## Weigall Sports Complex, Sydney Grammar School (SSD-10421) – Request for additional information – Acoustics

This letter details the review and response to the items included in the request for additional information from the NSW Department of Planning Industry & Environment in their letter dated 19<sup>th</sup> May 2021.

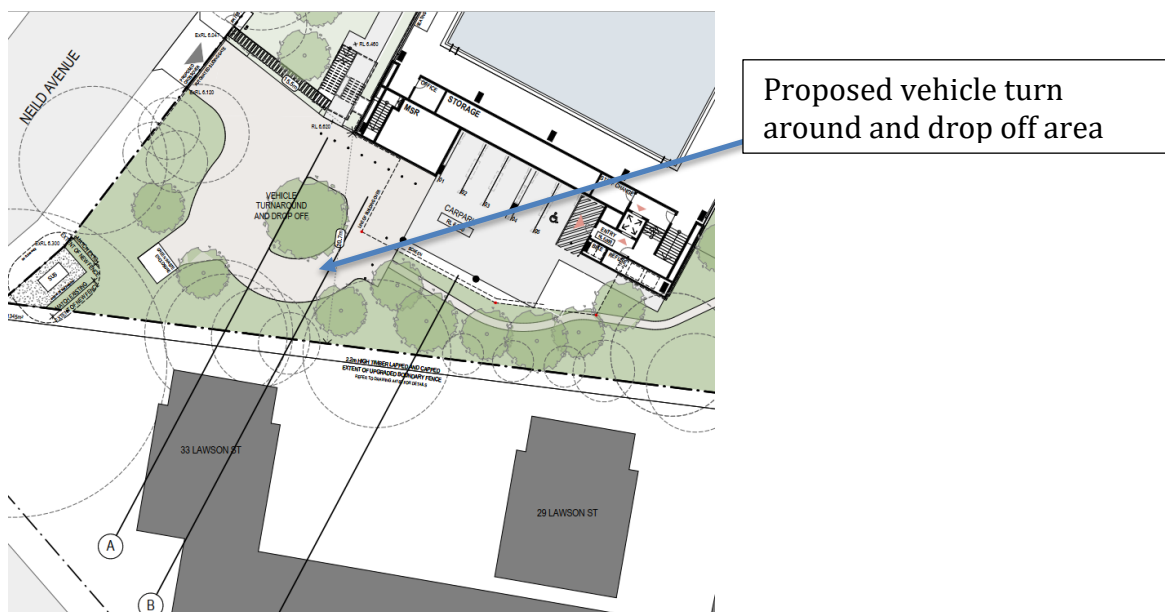
3. *Item 6 b) – Provide more information regarding the impact of car parking and pick-up/drop-off on neighbouring properties.*  
i) *Confirm predicted maximum noise levels, any exceedances, the effect of proposed mitigation measures.*

The assessment of maximum noise levels occurring from the proposed development has included noise generated as a result of cars using the vehicle turn around and drop off area located to the south of Building 1, as detailed in the figure below.

Based on the proposed use of the pick-up/drop-off area an assessment of potential for maximum noise level events has been undertaken. The assessment includes the potential for a maximum noise level events resulting from use of the drop-off/pick-up areas during night-time hours of 6am to 7am (night-time defined by the EPA as 7am to 10pm) to neighbouring residential receivers to the south of the site.

An assessment of the maximum noise levels, including the stage 1 screening test, has been undertaken for the external noise levels from the proposed vehicle turning and drop-off area, including the period of 6am to 7am (as defined as night-time period), and are included in the sample calculation below.

Based on the predicted noise levels above, compliance with the maximum noise level '*screening test*' from cars starting and closing of doors will be achieved. In addition to the stage 1 test the stage 2 assessment of possible *sleep awakenings* has also been undertaken.

Based on the results of the assessment detailed above the resulting maximum noise levels from the use of the proposed vehicle turning area and drop-off will comply with the relevant criteria for sleep disturbance events based on continuously occurring events. In the event that are limited number of maximum noise events generated on the turning bay and drop off area then the potential for sleep awakening is increasingly unlikely.

In addition to the assessment above the following mitigations are recommended:

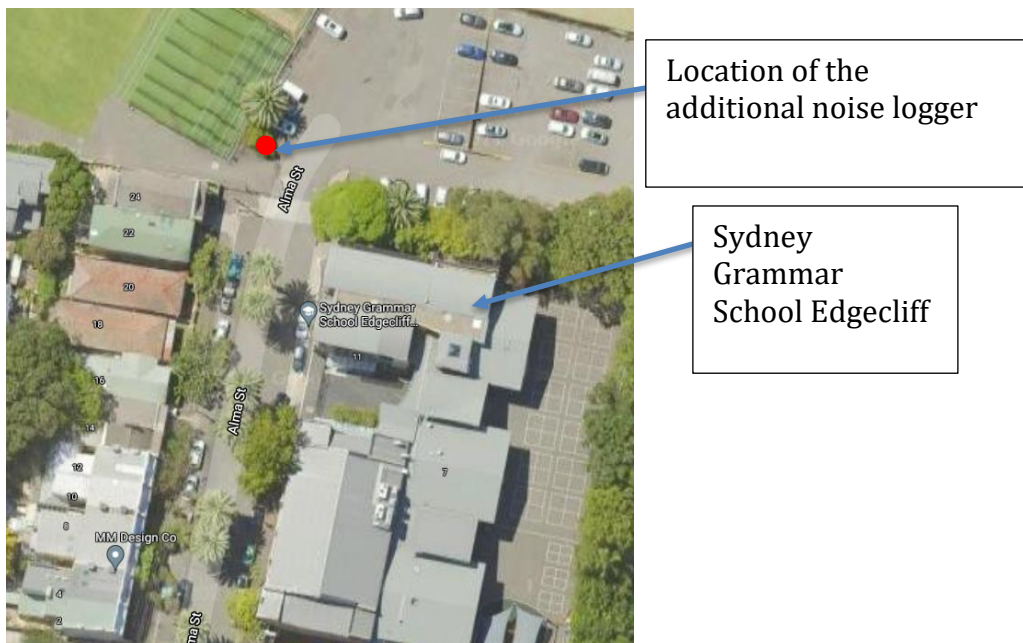
5. *Item 6 c) – Confirm the RBL and Noise Management Level for the Sydney Grammar School Edgecliff (education sensitive receiver).*

As part of the provision of this additional information noise logging has been undertaken at a representative location of the Sydney Grammar School Edgecliff, located to the east of Alma Street.

The noise logger was located at a representative location to the Sydney Grammar School Edgecliff and included a position to the north of Alma Street as detailed in Figure 1 below. The noise logger was positioned such that it did not include façade corrections.
